**V2500-D5 SERIES PROPULSION SYSTEMS SERVICE BULLETIN**

This document transmits Revision 1 to Service Bulletin EV2500-79-0040

**V2500-ENG-79-0040**

OIL - SCAVENGE OIL TUBES - ENGINE - INTRODUCTION OF REVISED SCAVENGE TUBES AND  
CLIPPING FOR THE NO.4 BEARING

Clipping Point 2557 - Before and after alteration  
Figure 24

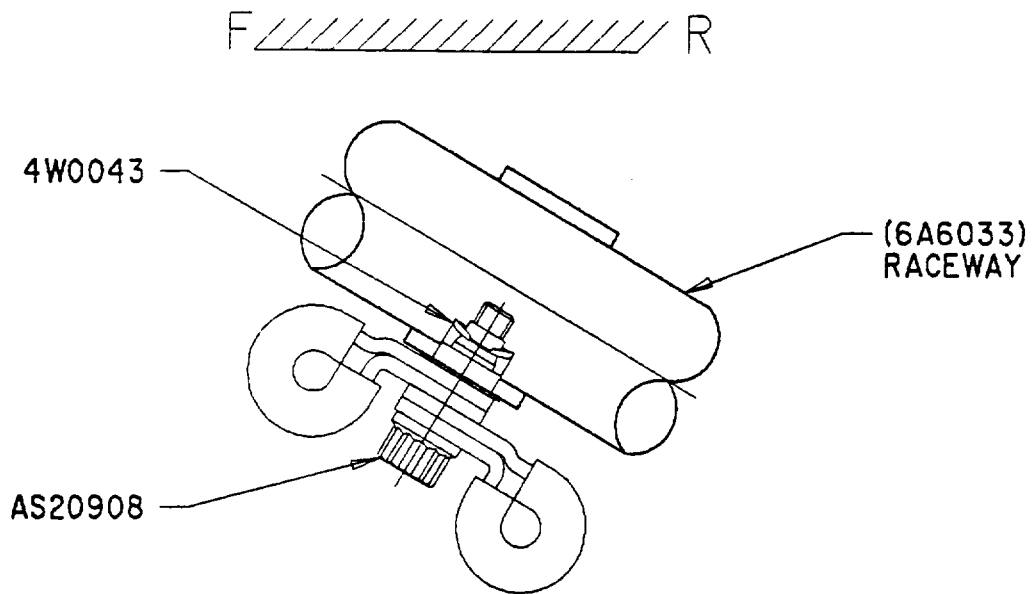
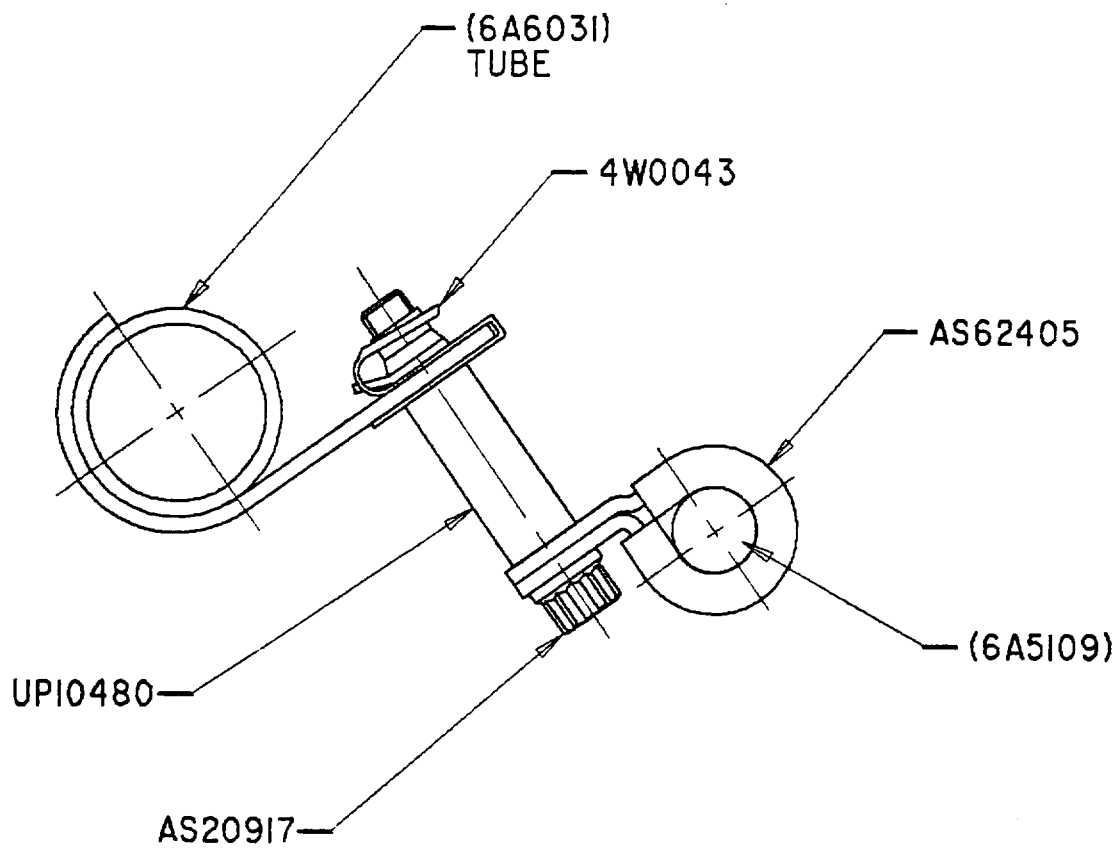
PROCEDURE	RELATED DATA
(a) Attach raceway to clip points CP2116, CP2119, CP2120, CP2121, CP2123 and CP2346	Refer to Figure 9, Figure 12, Figure 13, Figure 14, Figure 16 and Figure 21
(b) Attach raceway to changed clip points CP2111, CP2117, CP2118, CP2122, CP2124, CP2345 and CP2557	Refer to Figure 2, Figure 7, Figure 9 to Figure 17, Figure 20 and Figure 24
(c) Attach raceway to additional clip point CP2641	Refer to Figure 29

Clipping Point 2635 - Additional  
Figure 25

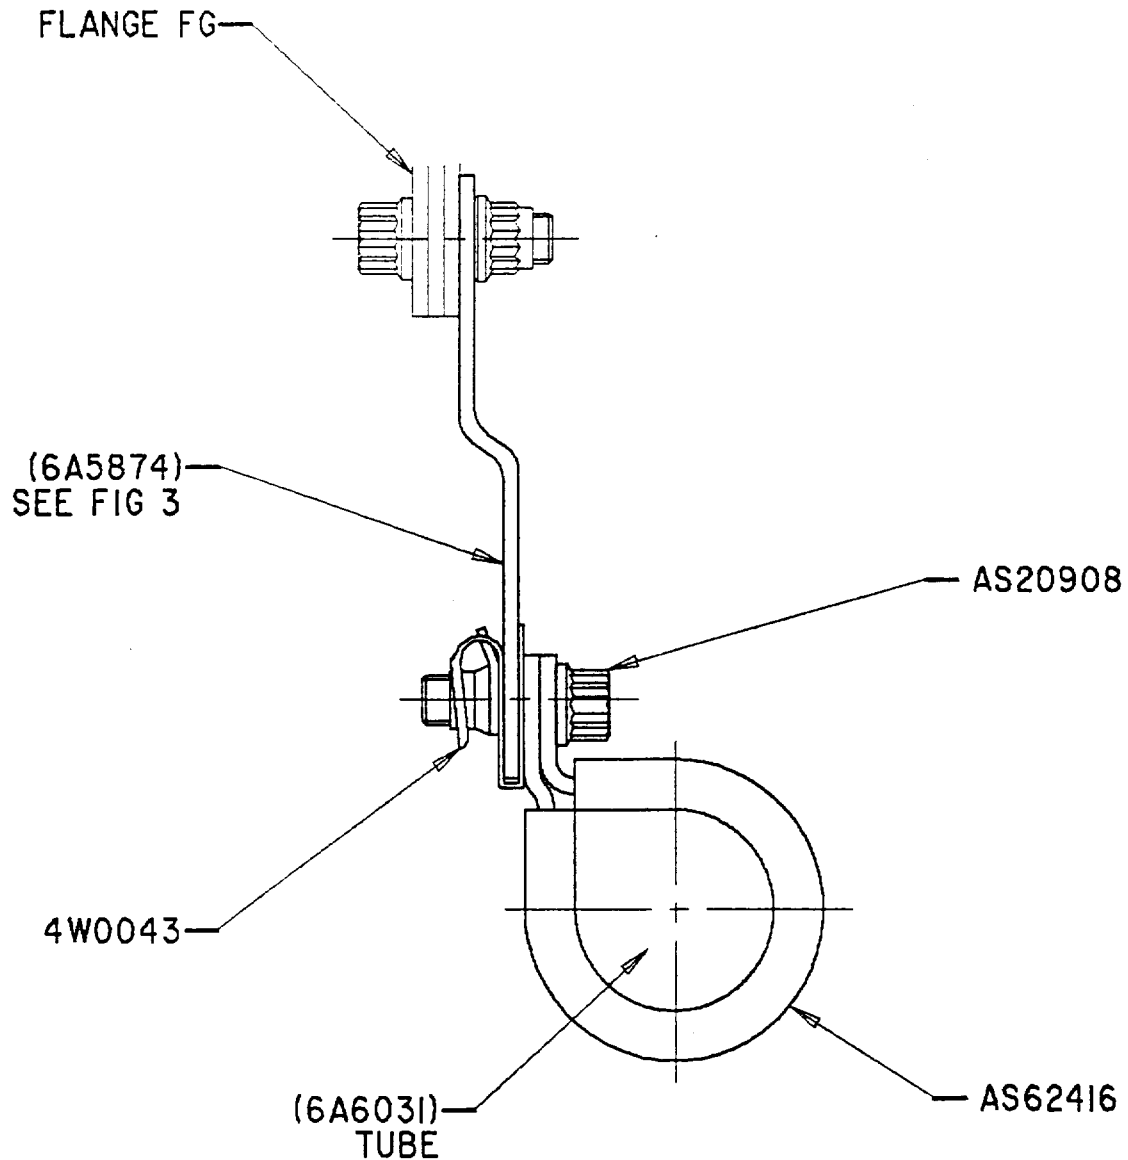
- (5) Install tube assembly 6A6031 to additional clip points CP2635, CP2636, CP2638 and CP2639

Refer to Figure 25 thru to Figure 28

Clipping Point 2636 - Additional  
Figure 26

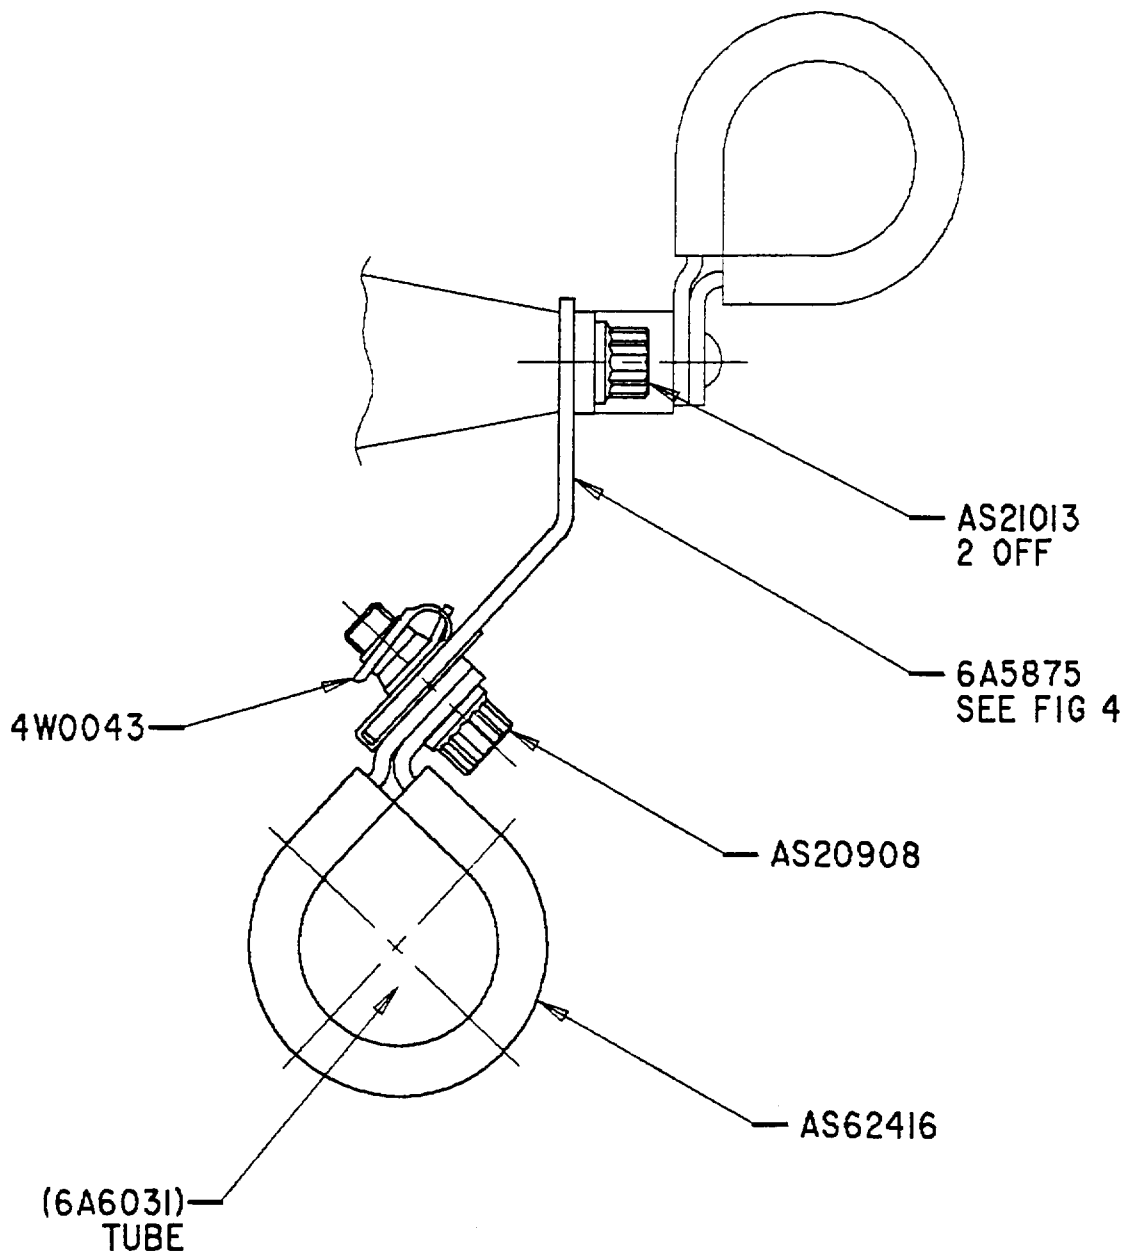
- (a) Attach CP2636 to additional bracket 6A6874

Refer to Figure 2 and Figure 26

Clipping Point 2638 - Additional  
Figure 27

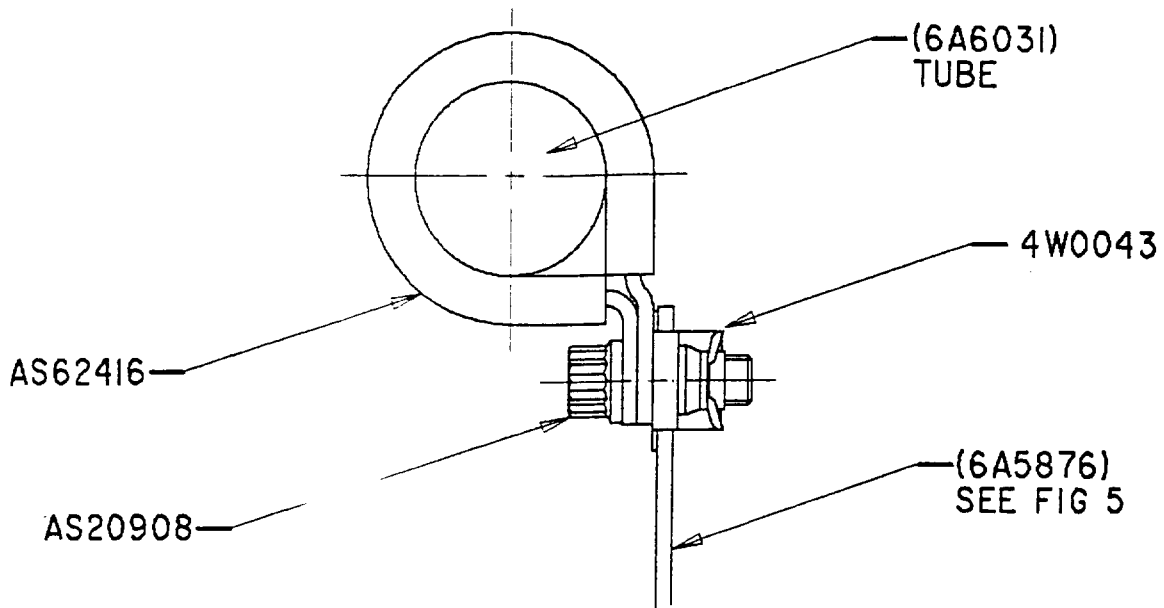
- (c) Attach clip point CP2638 to tube 6A6031 and then attach CP2638 to bracket 6A5875

Clipping Point 2640 - Additional  
Figure 28

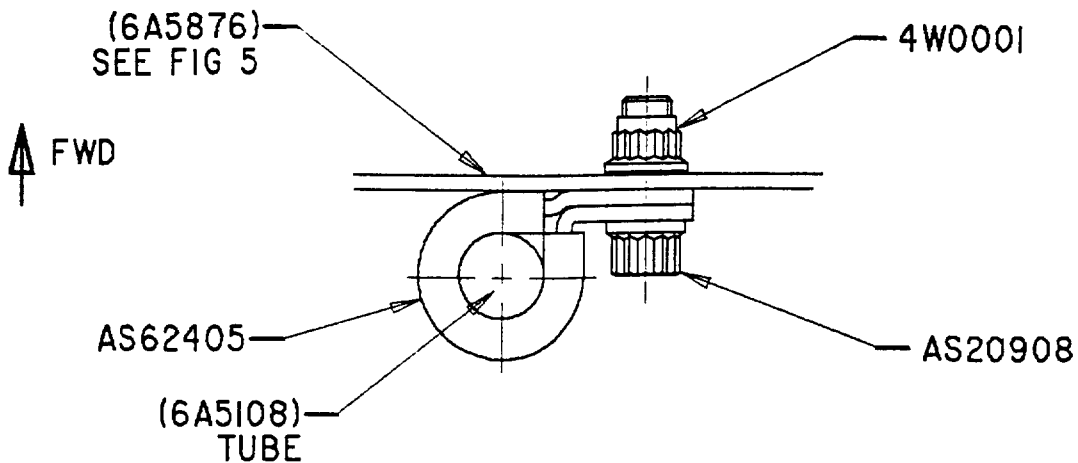
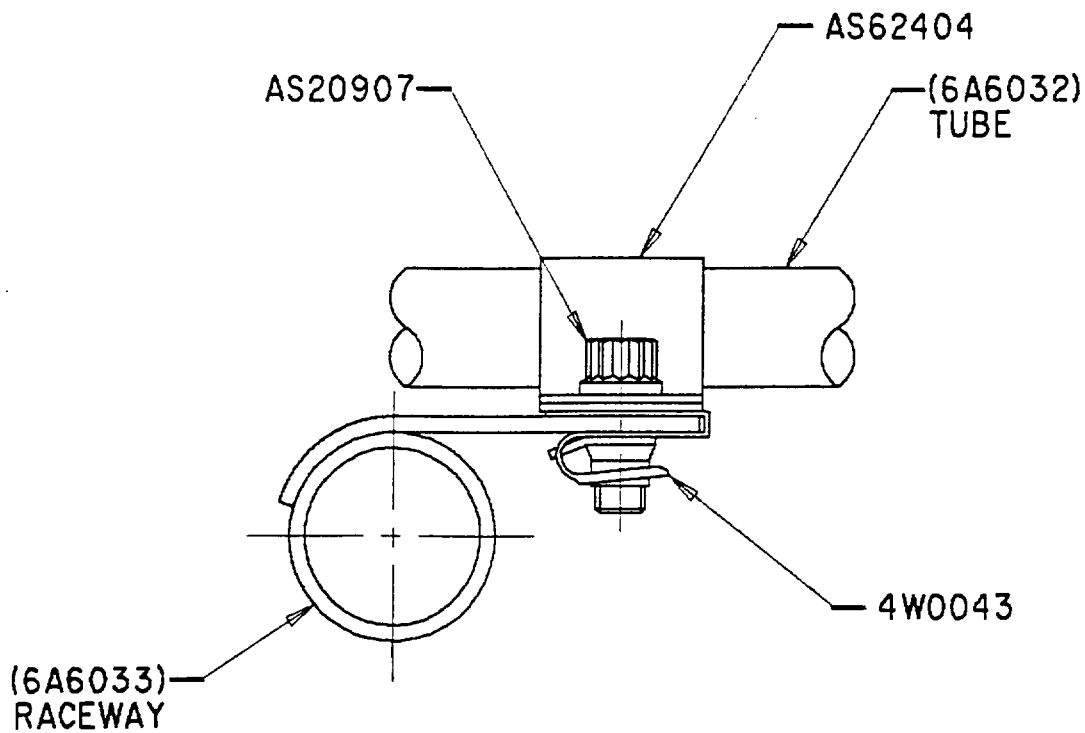
PROCEDURE	RELATED DATA
(a) Attach clip point CP2349 to bracket 6A5876	Refer to Figure 2 and Figure 23
(b) Attach tube 6A5108 to additional clip point CP2640. Then attach CP2640 to bracket 6A5876	Refer to Figure 2 and Figure 28
